Certified Action of the City of Raleigh Planning Commission

Case File / Name: IR-3-13 / Lakeview Ridge (formerly known as S-33-13)

SUBJECT: IR-3-13 / Lakeview Ridge

IR-3-13 / Lakeview Ridge – Preliminary Plan Lot Layout

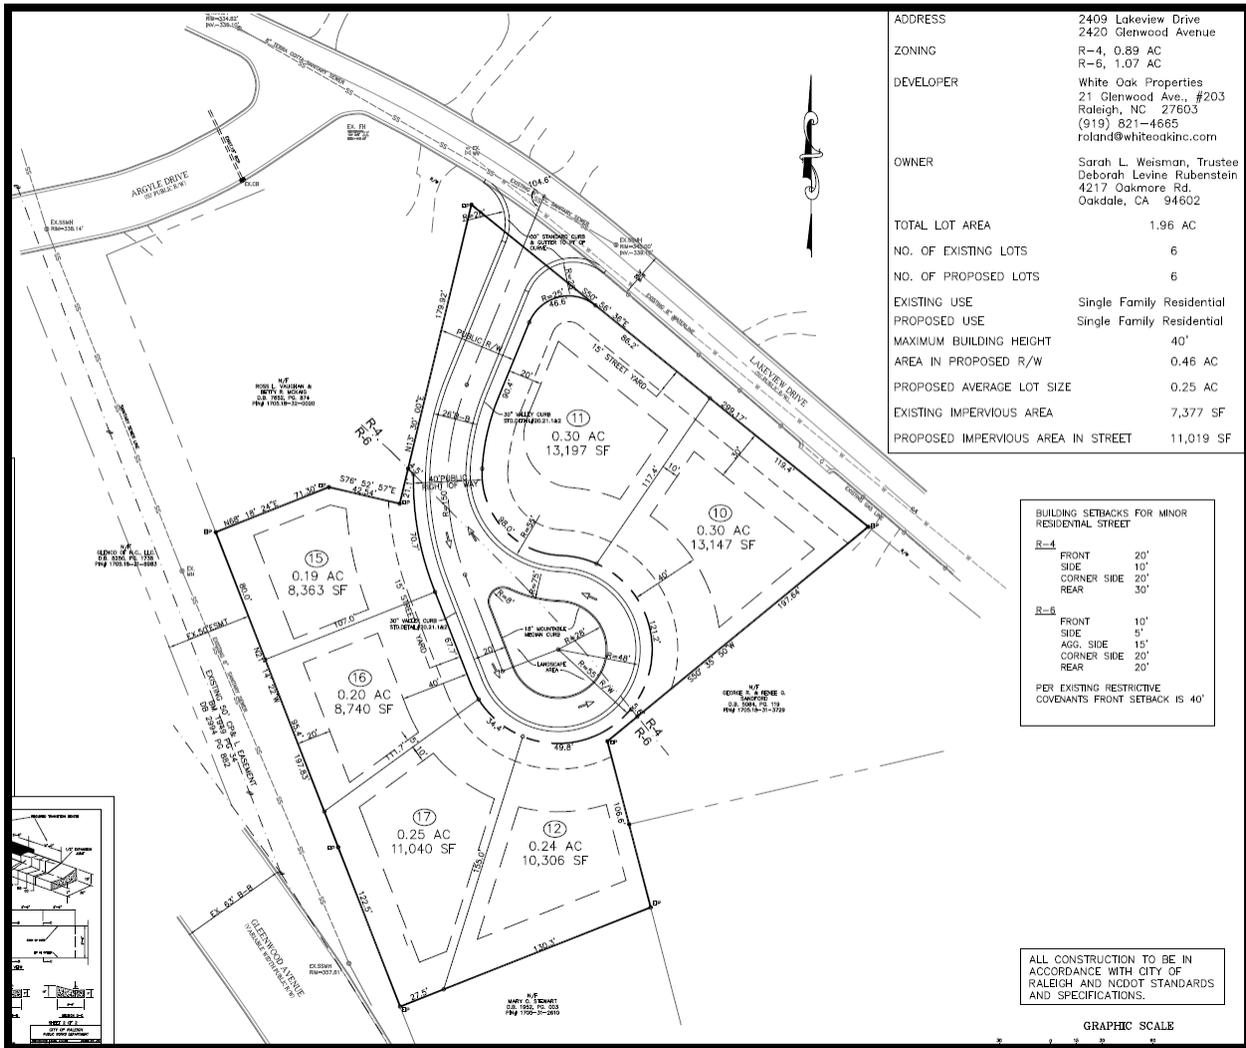
- (1) That the Planning Director accepts the proposed street right-of-way associated with this infill recombination. The cul-de-sac street does not bisect the property;

- (2) That an HOA complying with Chapter 47F of the North Carolina General Statutes is established and recorded at the Wake County Register of Deeds Office for the maintenance of the planting island and landscape in the cul-de-sac and annual inspection of the bio-retention measures. The HOA shall also have the right to maintain the bio-retention measures if not maintained by the lot owner. .

- (4) That a 5' sidewalk is constructed on Lakeview Drive for the frontage of this subdivision;
- (5) That a note appear on the recording plat stating, "That for lots zoned R-6, (lots 12 and 15) that a minimum 10' side yard perimeter setbacks is provided;

- (14) That driveways are located no closer than 3.5' to the side property line unless they are shared with an adjacent lot;
- (15) That when 75% of the permits have been issued for residential developments, then all of the proposed private drainage improvements or public improvements that are required to be accepted by the City for maintenance shall be completed. If this does not occur, then a financial security equal to 1.5 time the cost of the incomplete public or private improvements will be provided to the Public Works Department;

Lot lines are generally angled from the street in a similar manner as typical surrounding lots. Lots generally consist of no more than 4 primary lot lines as is typical of surrounding lots. The building envelope for the proposed new lots are placed in such a way that they are not one behind the other when viewed from the public street. Lots proposed may be adequately served by City services. The proposed lots may not be further subdivided.
